PRODUCT / PROCESS CHANGE NOTIFICATION

1.1 Company		STMicroelectronics International N.V
1.2 PCN No.		ADG/22/13222
1.3 Title of PCN		M series 1200V 40A IGBT TFS pad layout change
1.4 Product Category		IGBT
1.5 Issue date		2022-01-24

M series 1200V 40A IGBT TFS pad layout change

IGBT TFS: M series 1200V 40A Pad layout change

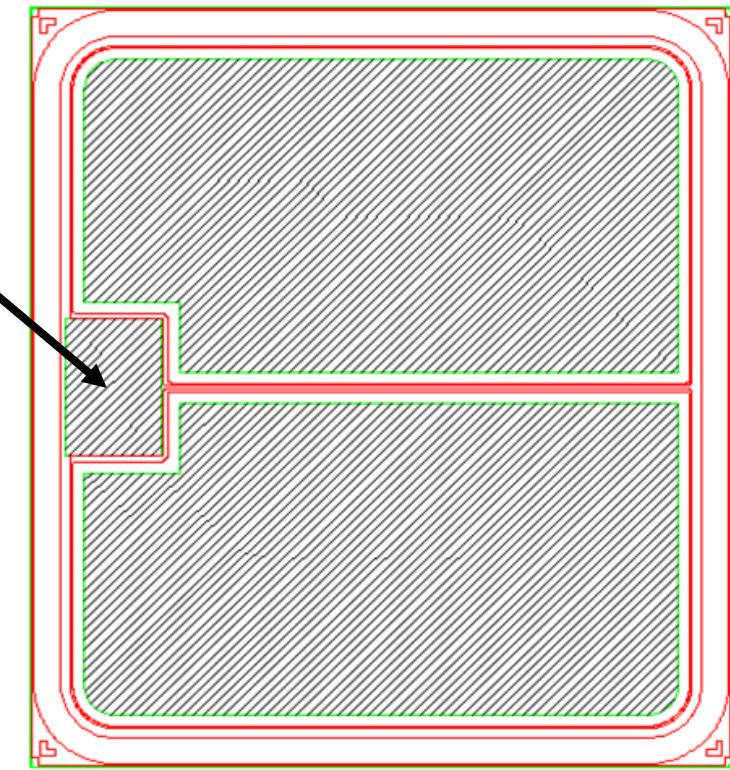
Old	New
4.1 Description	Gate pad of M series 1200V 40A IGBT TFS is currently positioned at the center of the die	Gate pad of M series 1200V 40A IGBT TFS will be moved to lateral position
4.2 Anticipated Impact on form,fit, function, quality, reliability or processability?	no change on form, fit and performance

Following the continuous improvement of our service and for wire bonding optimization reason, this document is announcing a pad layout change in our M series 1200V 40A IGBT TFS product family. This change involves gate pad that will be moved to lateral position as per attached document.
